Re: St. Lucie Units 1 and 2
Docket Nos. 50-335 and 50-389
Fourth Ten-Year Interval In-Service-Test Program Submittal
RAI Reply to Relief Request PR-04 (TAC No. MD7748)

RAI Reply for Pump Relief Request – PR-04
Low Pressure Safety Injection Pump Group Classification

UT 1 - LPSI PP 1B
LPSI PP 1B-4VA Pump Outboard Vertical

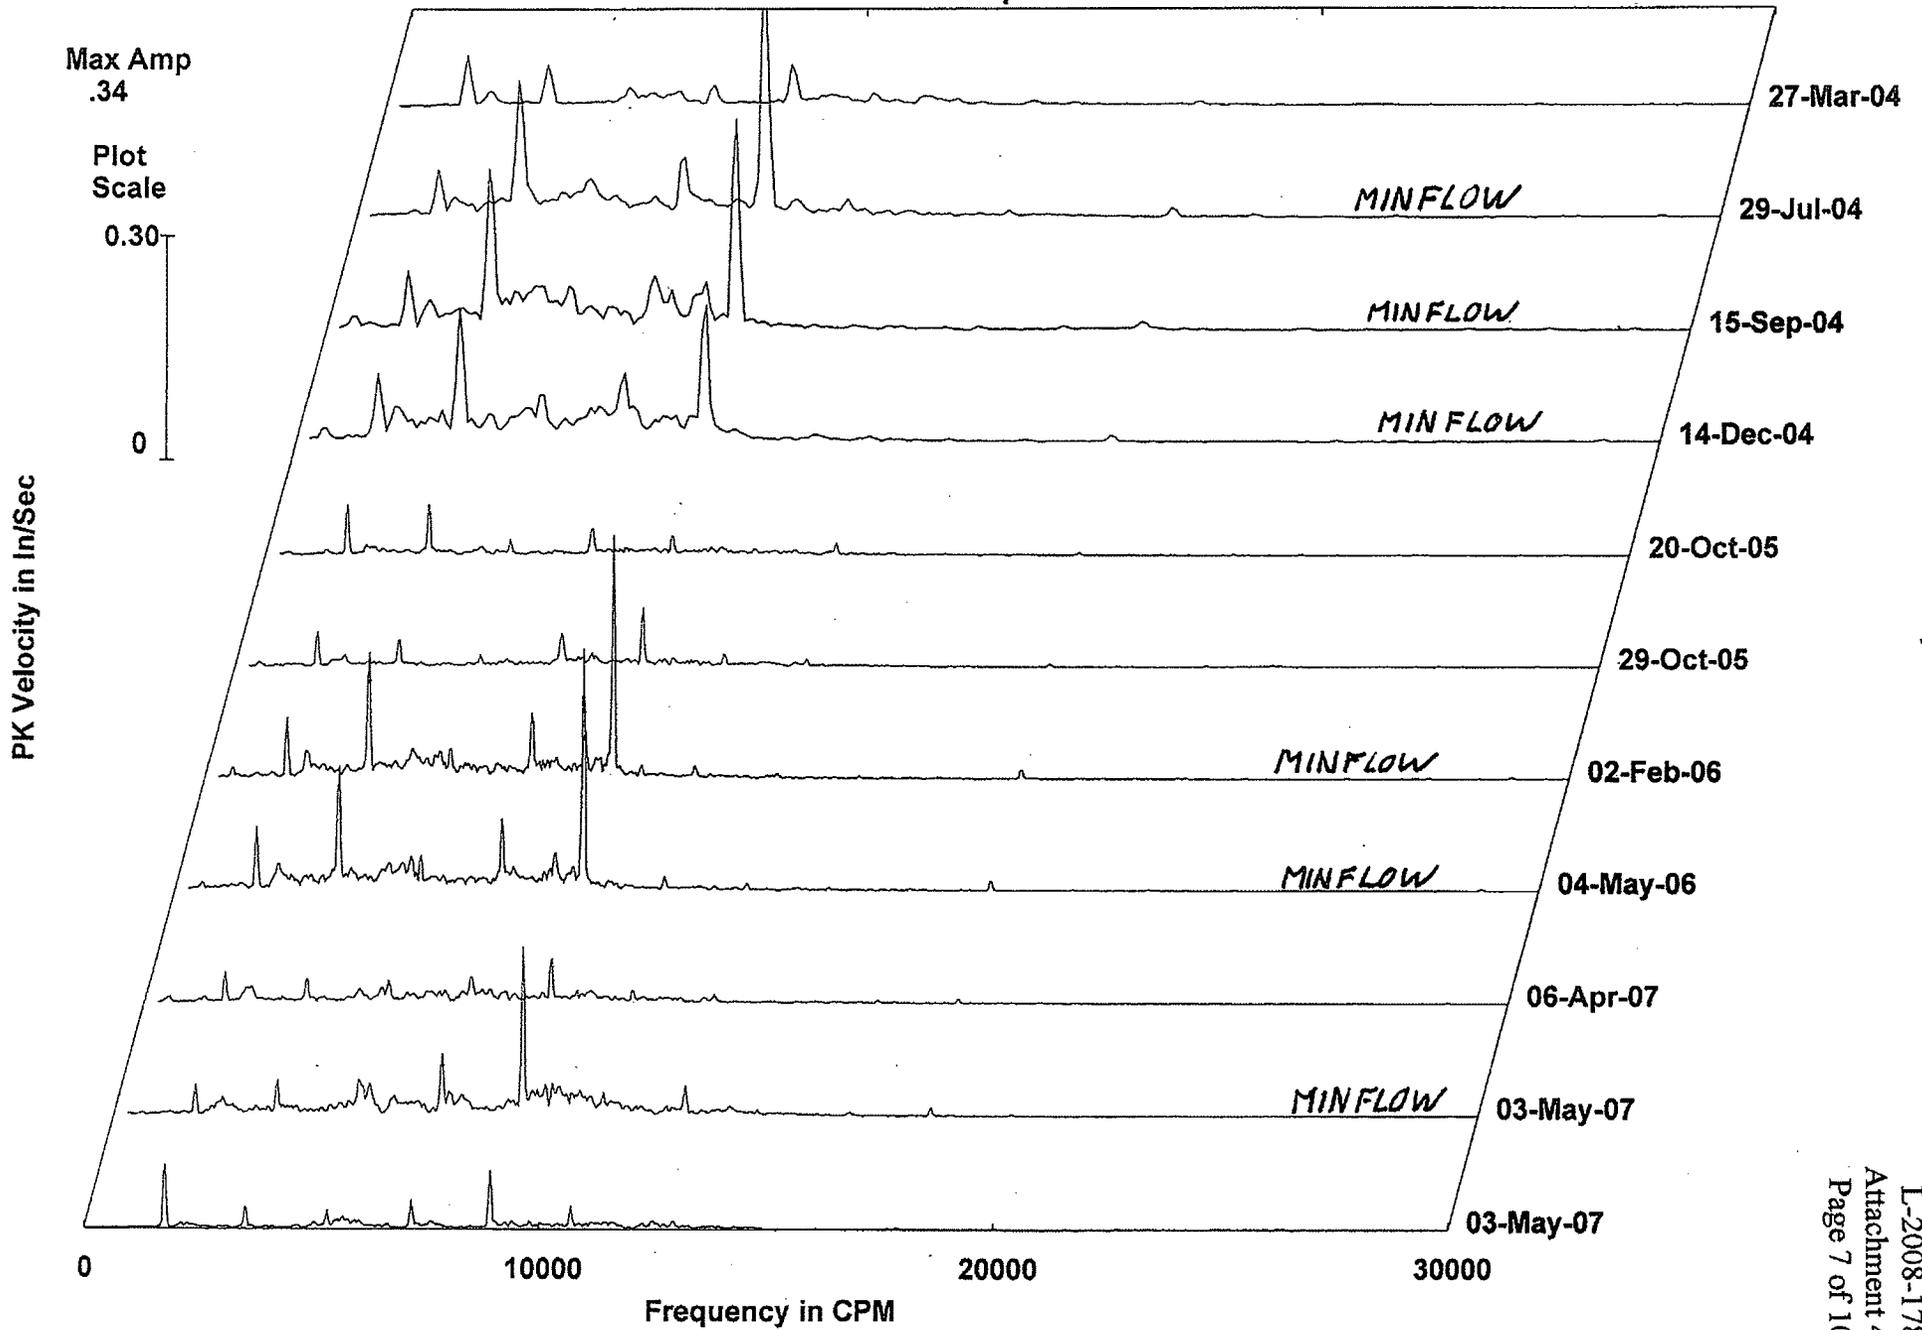
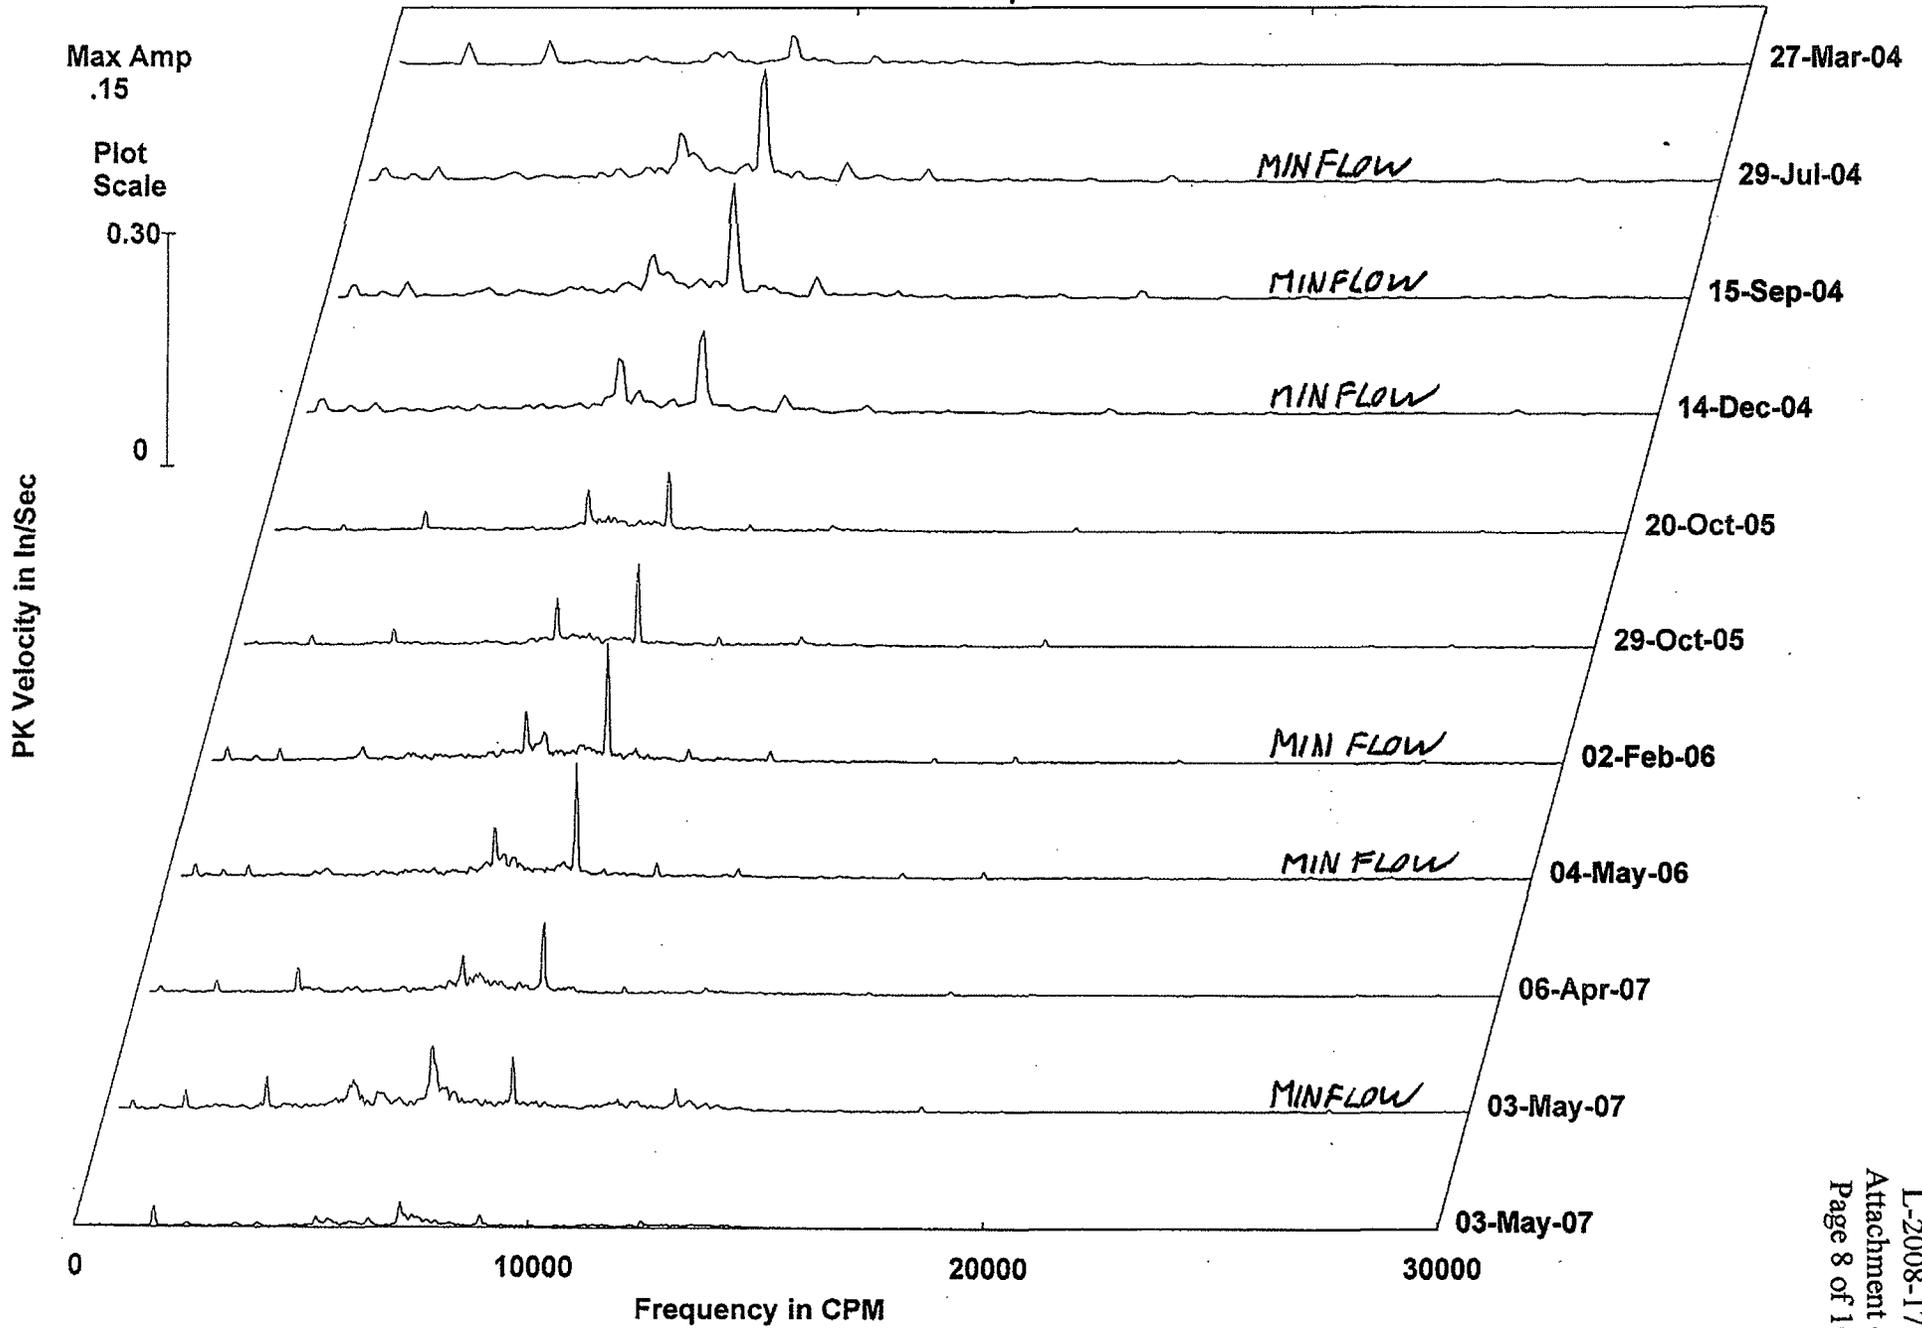
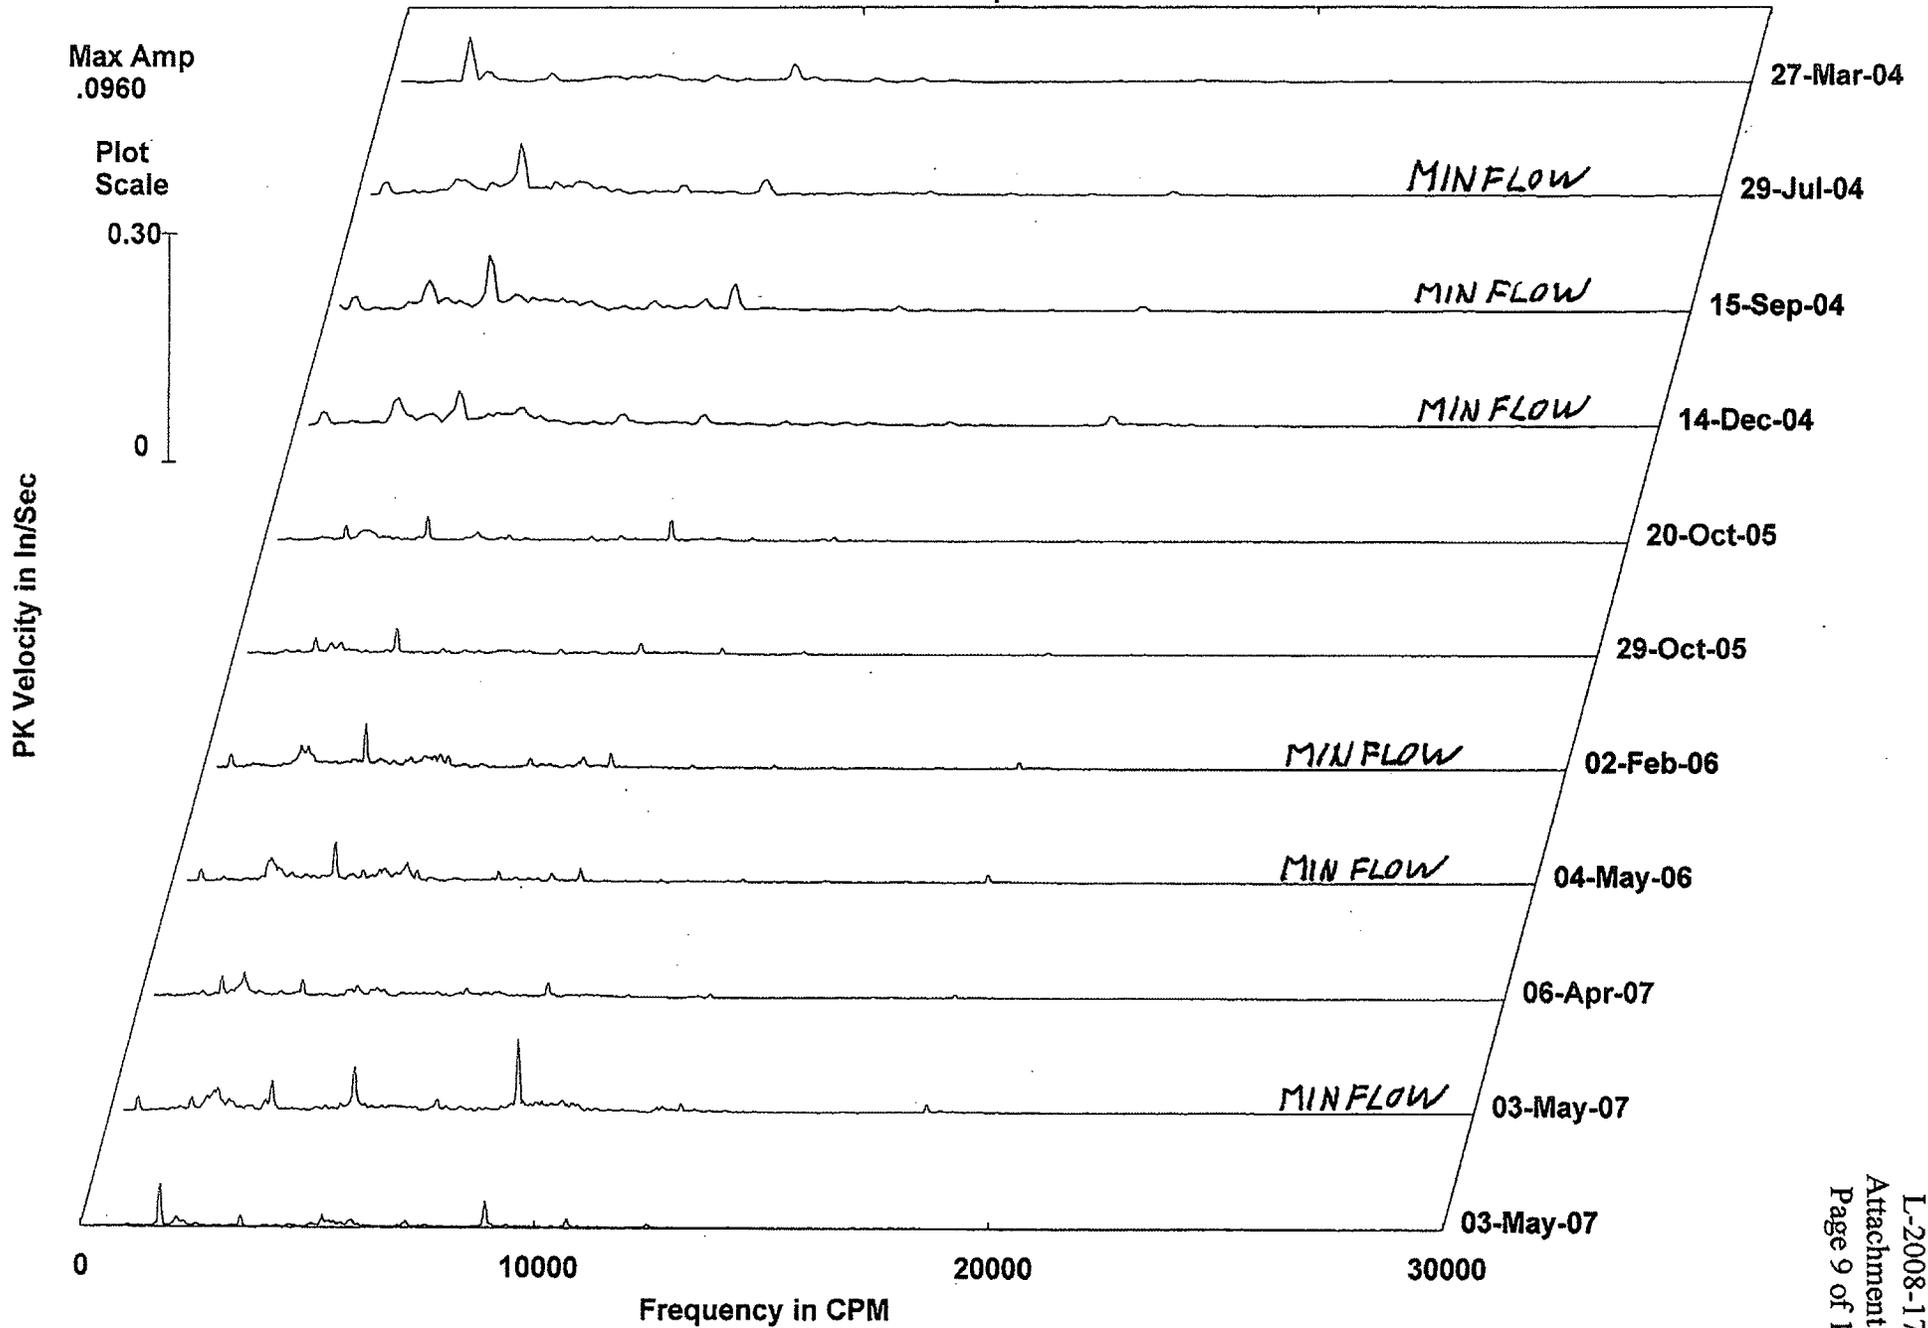
The following information is provided to supplement Relief Request Number “PR-04” submitted by Florida Power and Light Company under FPL Letter L-2007-144. This information is provided based on a telephone conversation between the NRC and FPL on July 2, 2008. Specifically, the NRC requested that the licensee provide basis and details for accepting the higher vibration values of 0.325 in/sec to 0.5 in/sec seen while testing the Unit 1 low pressure safety injection (LPSI) pumps under mini-recirculation flow conditions as described in previous PR-12 during the 3rd 10-year interval IST program. Additionally, the NRC requested that St. Lucie describe additional non-Code monitoring and spectral analysis activities performed on the LPSI pumps under design flow conditions during outages.

The Unit 1 LPSI pumps are included in the plant predictive maintenance (PDM) monitoring program, therefore, many years of spectral analysis and trend data from PDM test results are available for review (Attachments 3 and 4). PDM usually collects data when the pumps run at needed shutdown cooling (SDC) flows, but occasionally data is collected at the Section XI full flow and minimum flow tests. From the spectral patterns it can be seen that, at minimum flow conditions,

both pumps generate increased vibration levels. At low flow, vibration velocity levels at five running speed frequencies (5X), the vane passing frequency, are significantly increased due to elevated vane pass vibration since the water's velocity vector is not striking the volute tongue at the optimal angle. The increased vibration at the 2X frequency is a result of an abnormal pressure distribution in the volute that acts to asymmetrically load the impeller. Also contributing to the overall vibration increase is hydraulic broadband "spectral floor" energy generated by shock energy due to increased turbulence and internal recirculation flow.

As can be seen in Attachments 3 and 4 near BEP, the hydraulic vibration patterns are normal and expected. At lower flows there is increased vane pass (5X) and floor energy. As the flows return to near BEP the vibration patterns and levels return to normal. Therefore, though overall vibration can dramatically increase at low flow conditions, reaching 0.45-0.50 in/sec on these pumps, there is little sign that the pump condition would be degrading.

Bearing defect frequencies are generated from anti-friction (ball) bearings when the bearing surfaces are degraded. These frequencies are not present until a defect forms in the bearing itself. Depending on the specific location of the defect, the rolling elements will strike the defect at a certain frequency driven by the bearing geometry and the rotating speed. The bearing defect frequencies (inner race, outer race, ball, and cage) are normally calculated and compared to any spectral frequencies that appear. These frequencies are typically obvious when displayed in the spectral trend format, so changes are quickly apparent. As can be seen in Attachments 3 and 4 there are no bearing defect frequencies that have appeared in the spectrums.
